**Coastal Resilience Advisory Committee
Tuesday, October 5, 2021
Via Video Conference and Recorded**

A. Continued Discussion from September 28 Meeting on Draft Coastal Resilience Plan.

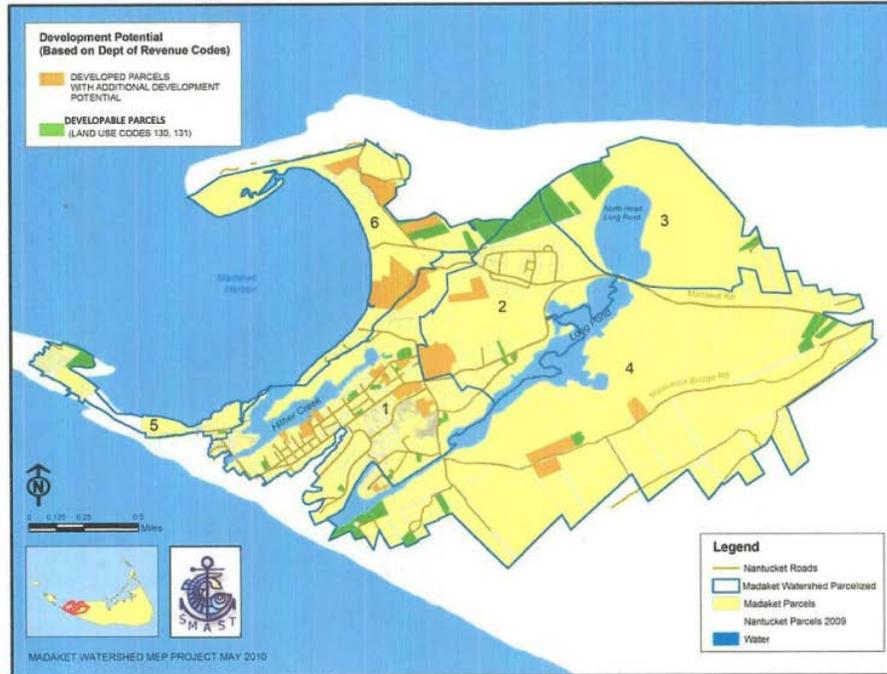
The DRAFT Coastal Resilience Plan ("CRP") includes two separate areas, 1) Madaket and 2) the North Shore. I am suggesting that the CRAC review this from the context of there being some overlap. Portions of what is currently shown in the DRAFT CRP as being "North Shore" are actually included in the Madaket Harbor Needs Area and in the Madaket Harbor Watershed Protection District (see attached graphic).

included in just one of the DRAFT CRP delineations as MADAKET rather than divided into two separate “chapters.” Additionally, the existing four Horsley Witten Heggerman (“HWH”) groundwater and surface water maps help to reinforce and define the west end boundary conditions most critical to protection of the aquifer. All four of the HWH maps clearly define the Madaket Harbor Watershed areas in relation to groundwater and surface water flows. A portion of the North Shore area depicted in the Draft CRP is clearly part of Madaket and is included in the Madaket Area Plan boundary. The area currently depicted in the DRAFT CRP as part of the North Shore should therefore be amended to be included into the Madaket “chapter.” A copy of the Area Plan boundary and a narrative description is included below for ease of reference. This boundary, including a portion of what Draft CRP depicts as “North Shore” is also shown as part of the Madaket Harbor watersheds in the Massachusetts Estuaries Project in Figure IV-5 (copy attached).

Therefore, my suggestion is that the portion of the Madaket Harbor Protection District currently shown as part of the North Shore in the DRAFT CRP be revised to become part of the Madaket chapter.
